Slope stability at Freshwater Point.

The Town and Country Planning Commission has requested an examination of the stability of the proposed subdivision at Freshwater Point.

Figure 1

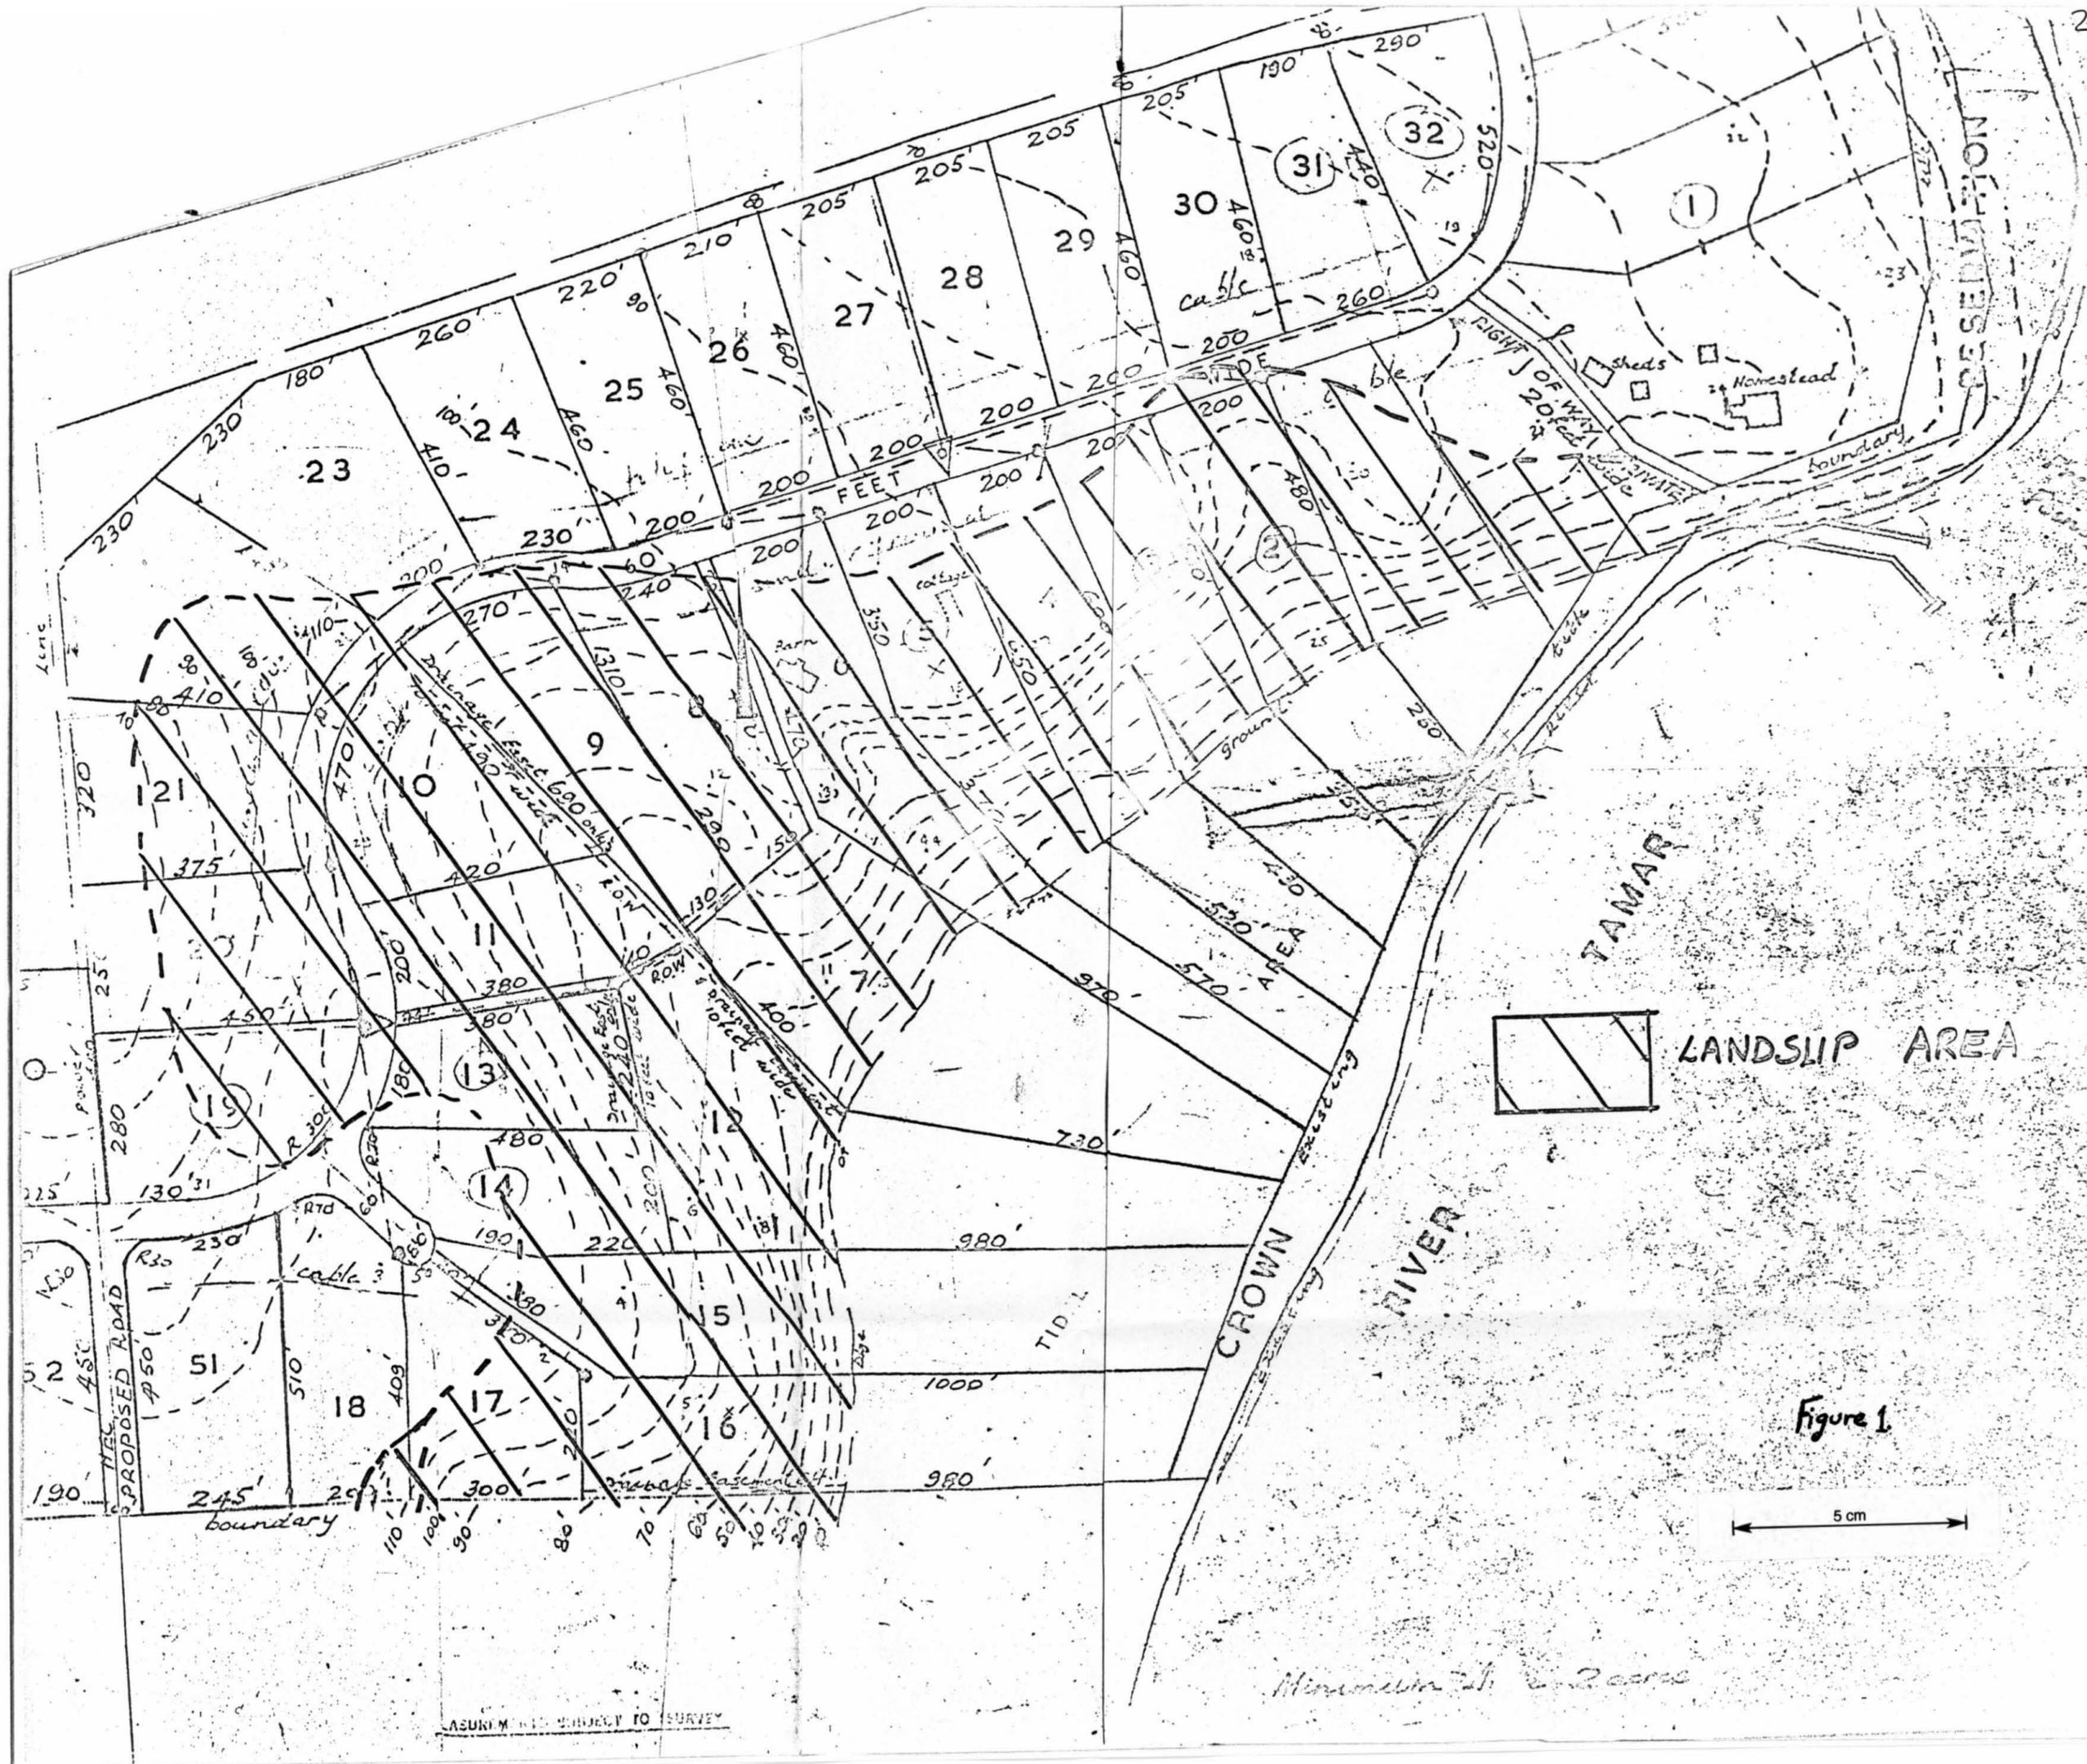
The entire area is covered with Tertiary sediments with the exception of a tidal flat which is of Quaternary age. The composition of the sediments varies considerably over short distances and ranges from almost pure clay to a mixture with a high content of gravel and silt. There are several small, shallow landslips situated on fairly steep slopes in the area. The land is slipping or has previously slipped downhill on Lots 3, 4, 5 and 6. Further slips occur in the orchard just outside of Lot 16. The area indicated on Figure 1 is not recommended for development.

Small trial pits excavated by back-hoe may provide further geological information and possibly reduce the extent of the condemned area. Such pits should only be dug under geological supervision as new sliding could be induced if they are not carefully sited.

The land outside the condemned area should be drained and deep road cuttings on the slopes avoided. In general, houses should be situated on the flattest part of every block and well away from the crest of the slope.
